IDAP REPORT

Property:	31 Fitzgerald Crescent STRATHFIELD Lot 39 DP 15823 DA2021/190
Proposal:	Demolition of existing structures incl. existing swimming pool, torrens title subdivision of land creating a new battle - axe lot, construction of a new two storey dwelling on each lot, construction of in-ground swimming pool to new rear (battle axe) lot, landscaping and site associated works to both new dwellings.
Applicant:	DSY Holdings
Owner:	DJ & S Younan
Date of lodgement:	29 July 2021
Notification period:	4 August – 20 August
Submissions received:	Nil
Assessment officer:	J W Brown
Estimated cost of works:	\$1,780,400.00
Zoning:	R2-Low Density Residential - SLEP 2012
Heritage:	No
Flood affected:	No
RECOMMENDATION OF OFFICER:	APPROVAL

EXECUTIVE SUMMARY

Figure 14: Rear lot parking with carport setback 1.5m

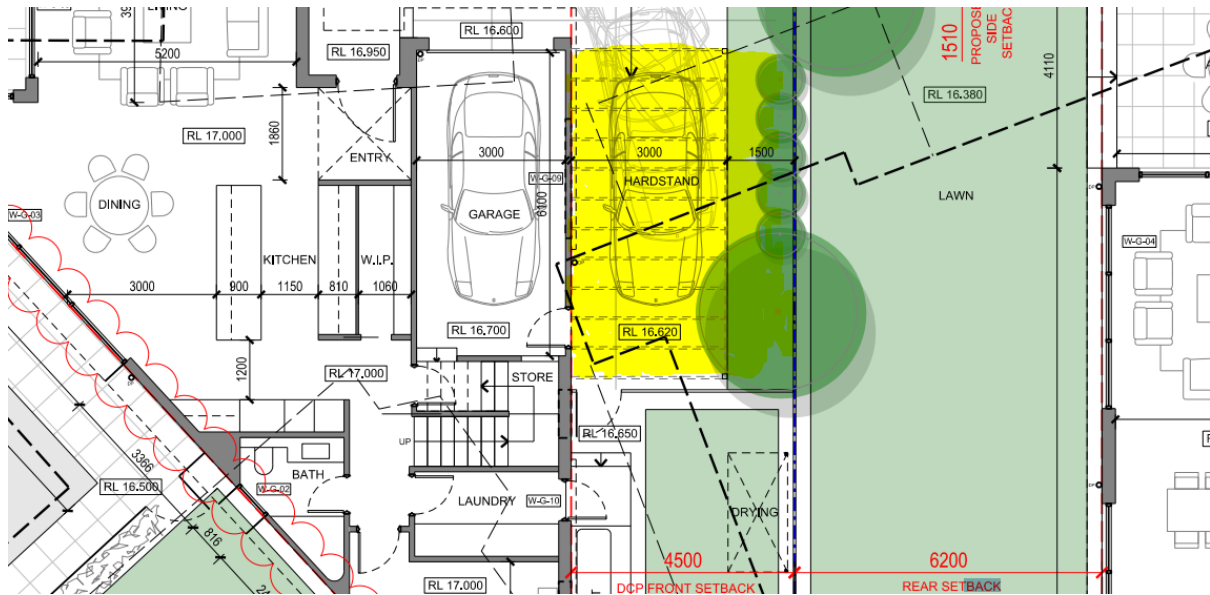
The proposed development satisfies most of the setbacks to the boundary except for two minor non-compliances. The front setback of the rear battle-axe lot (No.31a) has an attached carport that reduces the setback to 1.5m to the boundary. Due to this being an open form structure and still having a reasonable setback to the boundary, it is unlikely to impact on the neighbouring property. The rest of the proposed dwelling house meets the required 4.5m therefore satisfying the control. Thus, the variation is acceptable. The combined side setback is not relevant in this proposal due to the unique shape of the site and that all side boundaries meet the minimum of 1.2m, thus the non-compliance is acceptable.
